PALISADES NUCLEAR GENERATING PLANT

Amendment No.18
License No. DPR-20

CHANGE TO THE TECHNICAL SPECIFICATIONS

CONSUMERS POWER COMPANY
Palisades Plant Organization

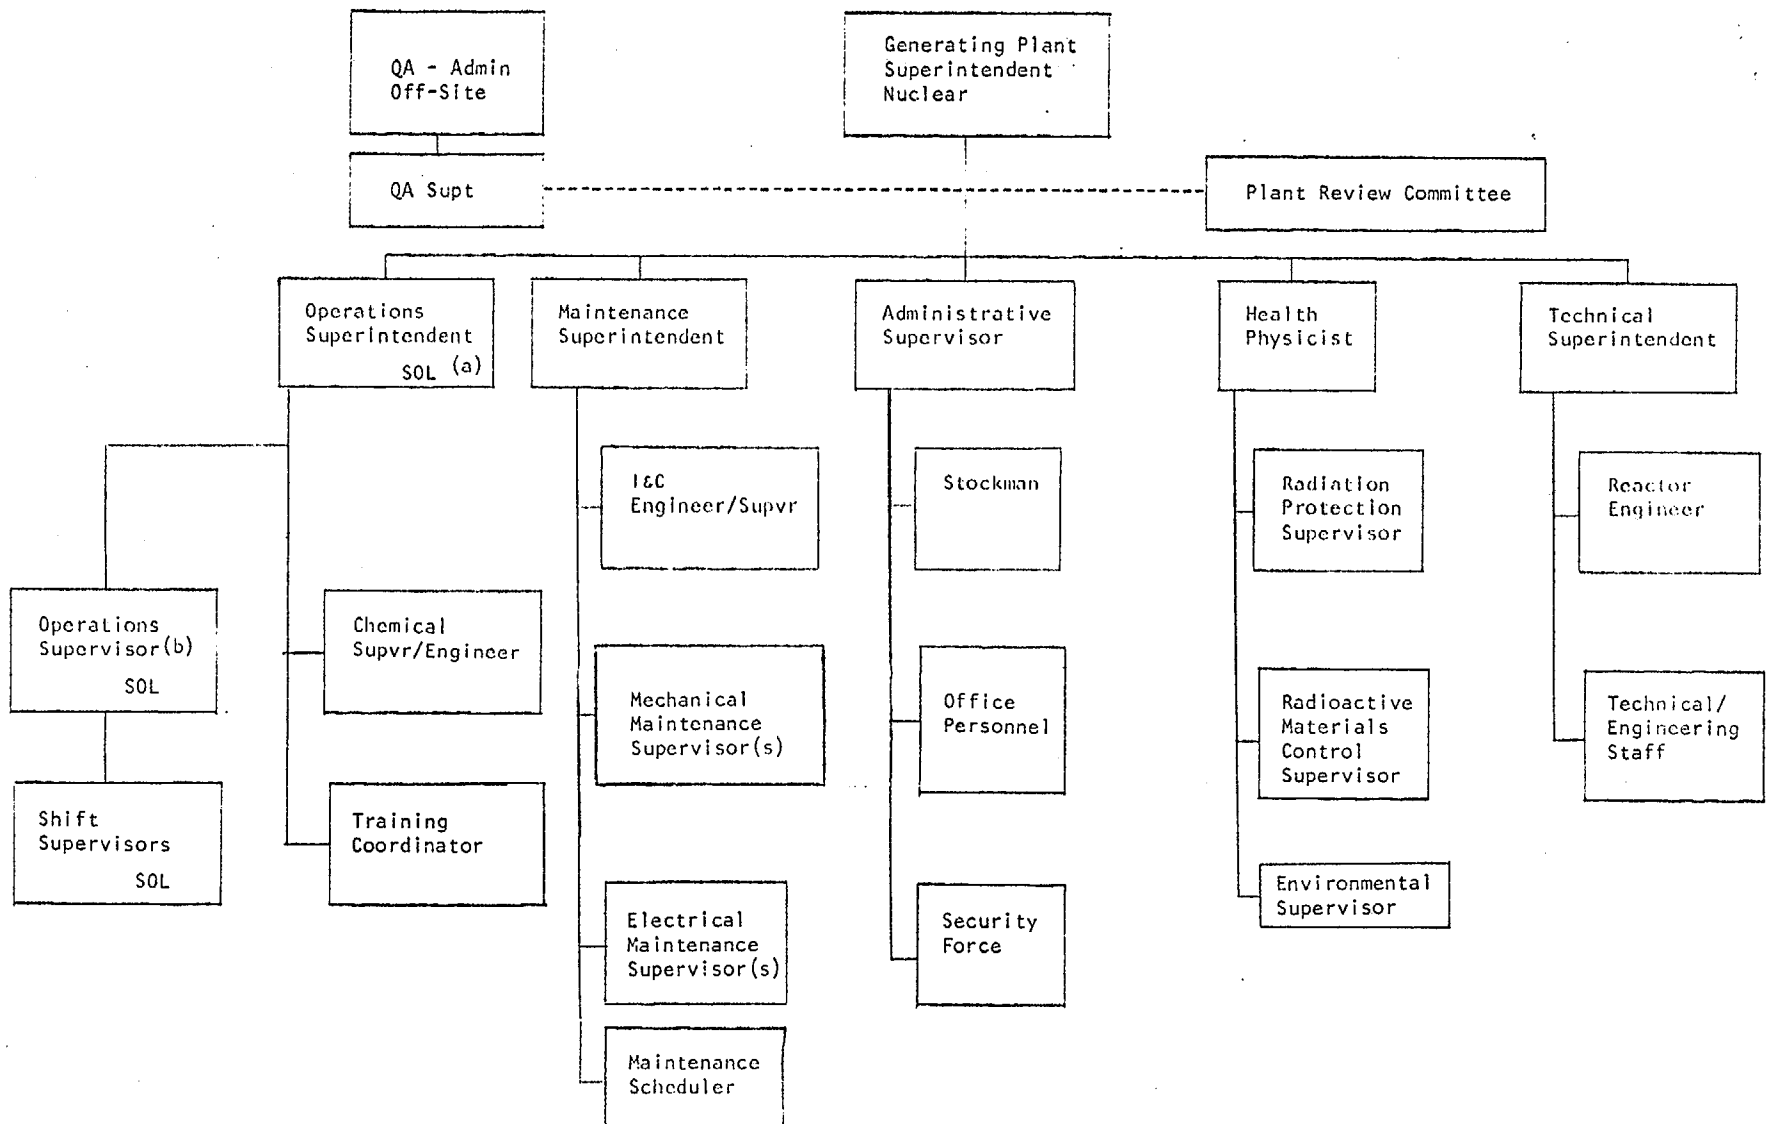
The amendment revises the plant staff organization by adding the position of Environmental Supervisor.

Remove page 6-3 and insert the revised page 6-3.

(a) The Operations Superintendent need not hold an SOL provided he meets the other requirements of 6.3.1 of these specifications and the position of "Operations Supervisor" is filled. Under these conditions, the Operations Supervisor shall be responsible for directing the activities of licensed operators.

(b) This position need not be filled if the Operations Superintendent holds an SOL.
